NUMBER: 23-016-13
GROUP: Body
DATE: April 20, 2013

SUBJECT:
 Driver And/Or Passenger Seat Fore/Aft Movement During Acceleration And/Or Braking

OVERVIEW:
 This bulletin involves replacing the power seat track drive block bolts on front driver and/or passenger seat.

2011- 2013	(LC)	Challenger
2011- 2013	(LD)	Charger
2011- 2013	(LX)	300

Fig. 1 Replace Drive Block Bolts

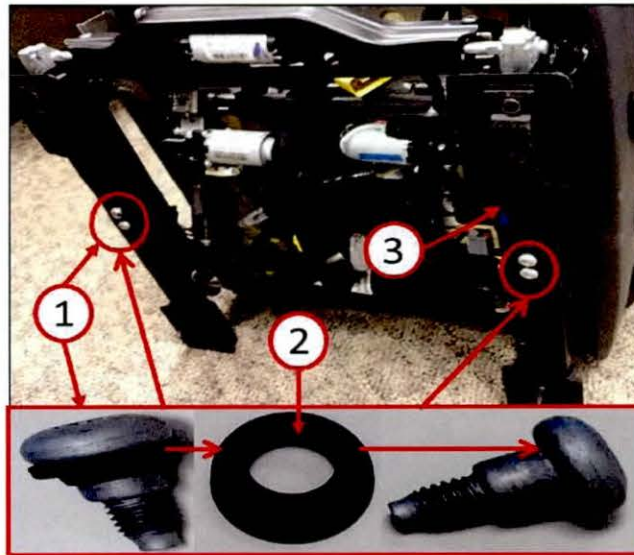
2. Remove one of the drive block bolts (1) from the bottom of the seat frame at a time and remove the plastic spacer (2) from the old bolt and reinstall it on the new bolt p/n 68203613AA.
3. Reinstall the new bolt into the bottom of the seat frame (3) and tighten it to 15Nm(11ft/lbs.). Repeat for the remaining bolts and/or seat.
